INFORMATION SUMMARY
TO ACCOMPANY REQUESTS FOR PROPOSAL FOR
CREOSOTE CONTAMINATION STUDY IN ST. LOUIS PARK

POLLUTION CONTROL AGENCY, ROLE AND EVALUATION OF BARR REPORTS

MINNESOTA GEOLOGICAL SURVEY -- EVALUATION OF BARR REPORT:

FIGURE 7 Barr Report
 THICKNESS OF THE PLATTEVILLE LIMESTONE FORMATION (FEET)
 (indicating approximate limits of buried bedrock valleys)

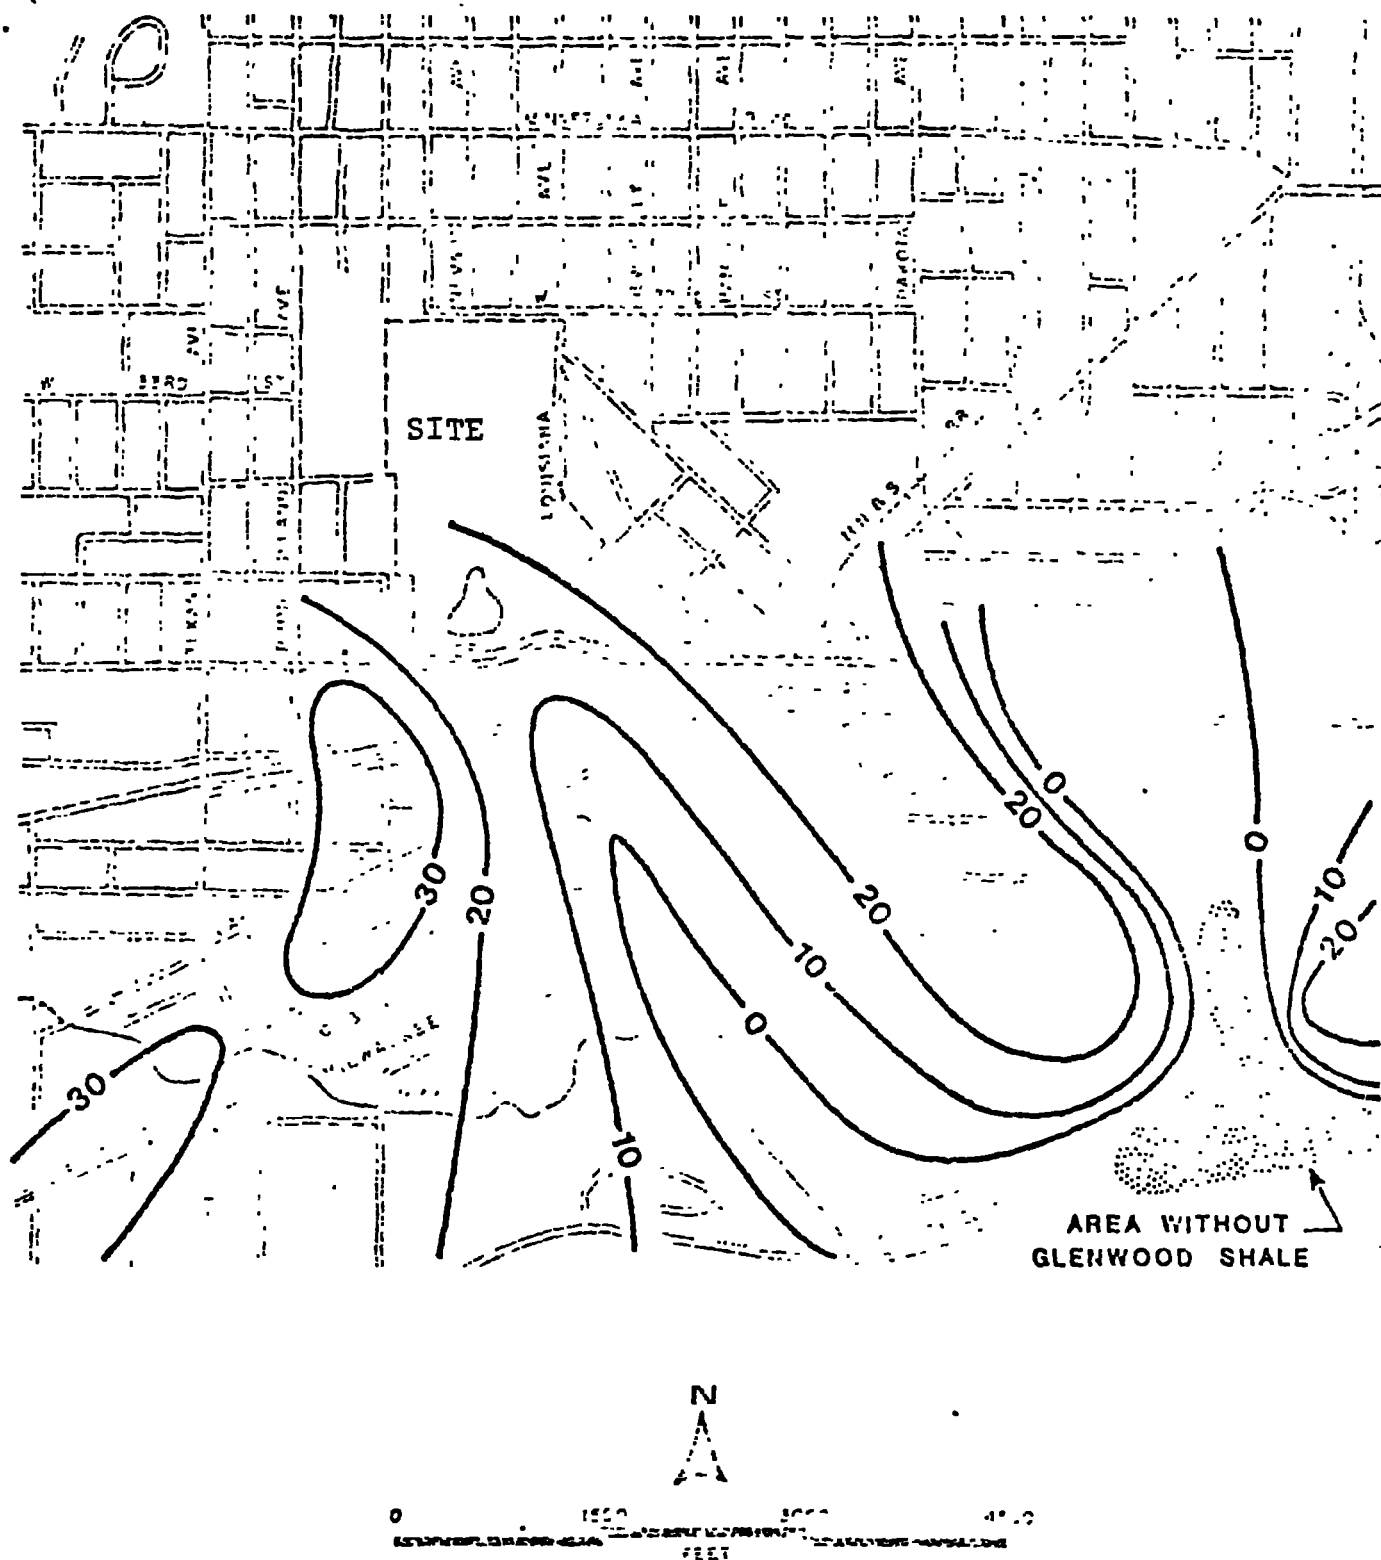
A bedrock geologic and topographic map based upon our copies of borings ST-1, ST-53, and ST-64 and our interpretation of the Methodist Hospital data indicates that a bedrock channel cut into the St. Peter Sandstone extends at least as far north toward the old creosote site as the extension of Louisiana Avenue over the Chicago Milwaukee, St. Paul, and Pacific Railroad tracks. We are enclosing a copy of this map. The generalized bedrock topography compiled from waterwell records and test boring logs lends support to the existence of a southeastern bedrock channel. The width of this channel cut into the St. Peter Sandstone could be approximately one city block or about as wide as the gorge cut into the St. Peter Sandstone just downstream from Minnehaha Falls. The southeast channel shown in figure 7 of the Barr report is similar in width but they interpret the bottom of this channel as lined with Glenwood shale.

In addition to the southeastern channel, we suggest the channel underlying Wooddale Avenue (figure 7) is also probably cut into the St. Peter Sandstone and not just into the Glenwood Formation. Records for the abandoned St. Louis Park well at 6021 West 36th Street and for the Minnesota Rubber Company well at 3630 Wooddale Avenue each report St. Peter Sandstone as the first bedrock penetrated. The record of the Milwaukee Railroad well at Wooddale Avenue and the railroad tracks reports only four feet of limestone and shale overlying the St. Peter Sandstone and suggests the area between these three wells may mark the northern edge of a St. Peter channel whose center would lie to the southeast. We are enclosing copies of the three well logs.
